Technical Service Bulletin: TSB120225

Low Temperature Aftercooler (LTA) Water Pump Option Upgrade For QSK45 and QSK60 Engines With HPI Fuel System and QSK60G Engines.

Figure 1, Greased bearing LTA water pump.

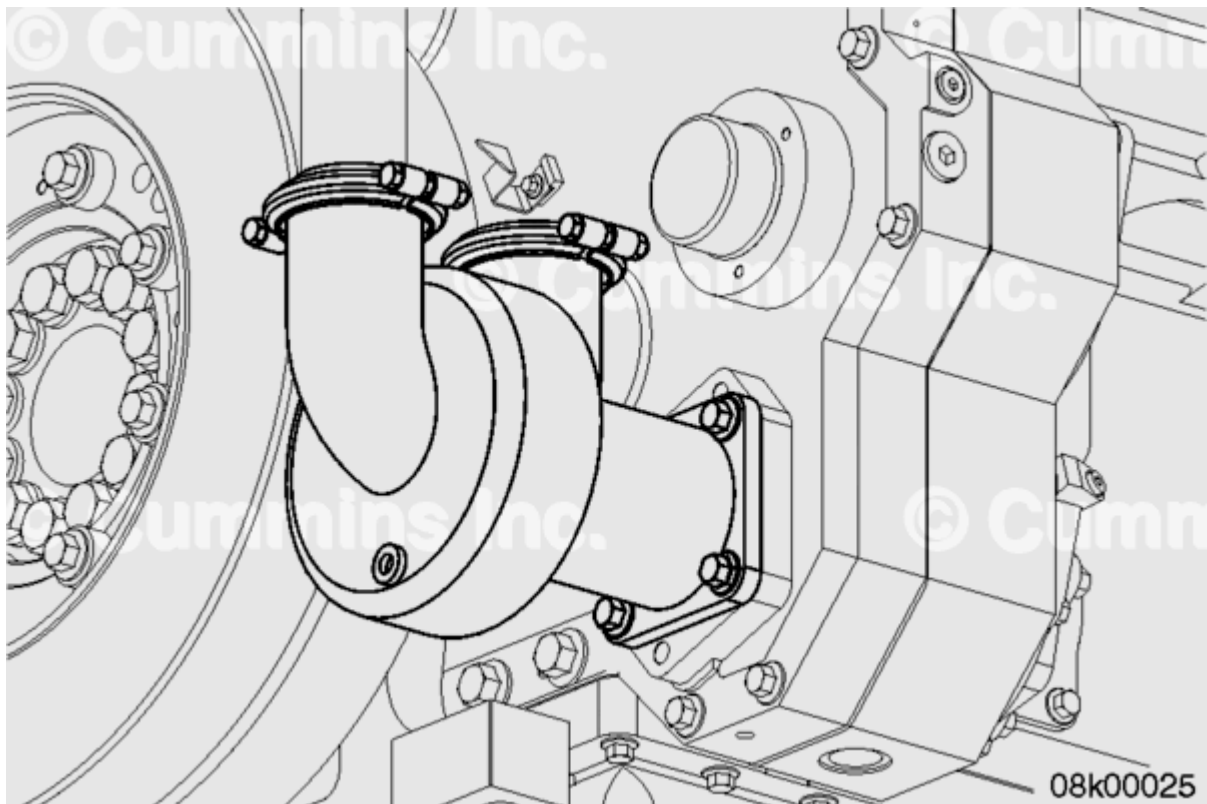
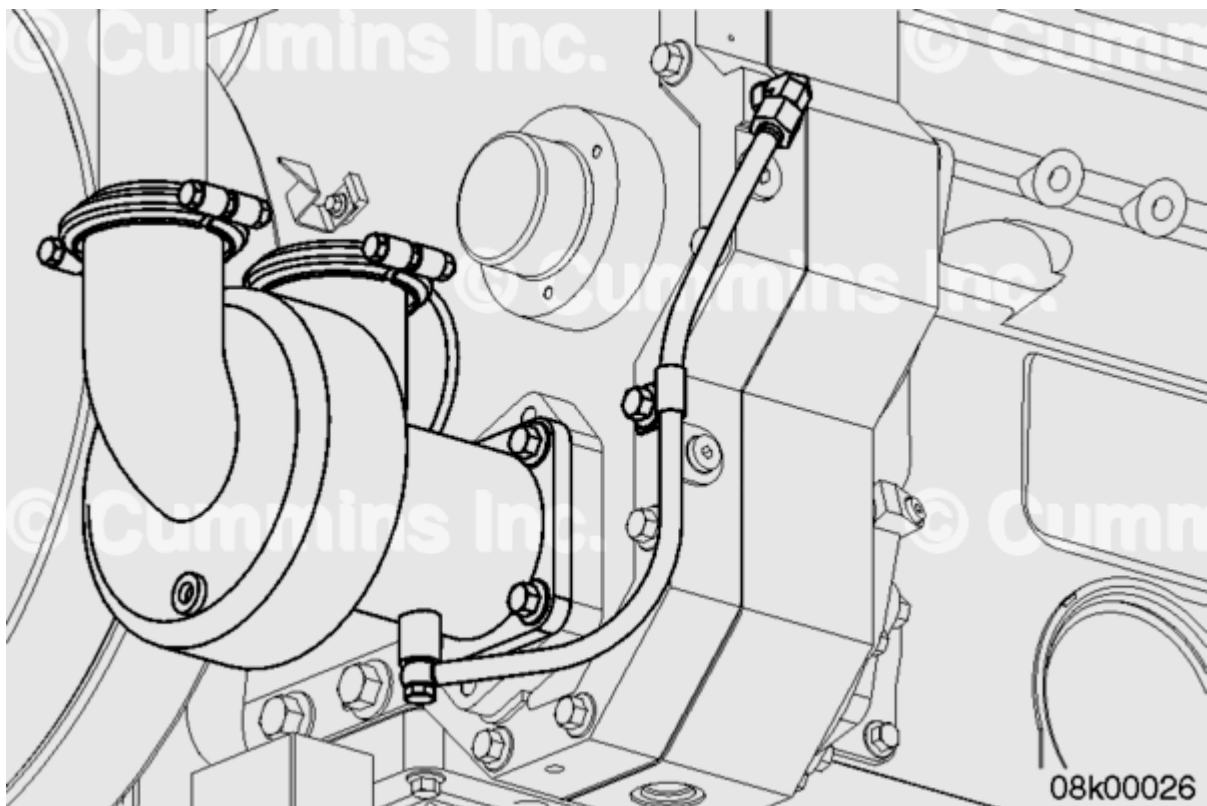
This document informs the field about a possibility to upgrade the greased bearing LTA water pump, Part Number 4085944, to the oil supplied bearing LTA water pump, Part Number 3640492, during a pump replacement service event or an engine rebuild process the for use in QSK45 and QSK60 engines with HPI fuel system and QSK60G.

On factory built engines, if a new oil supplied bearing LTA water pump, Part Number 3640492, is to be installed in place of an old greased bearing LTA water pump, Part Number 4085922, the following additional parts are required:

Additional Part Numbers Required		
Part Number	Quantity	Part Description
3638095	1	Flexible Hose
3963982	2	Sealing Washer
68152	2	Clip
3682701	1	Male Union Elbow
3638094	1	Banjo Connection Screw

A service kit, Part Number 4955807, has been released which contains LTA water pump, Part Number 3640492, and all the above components.
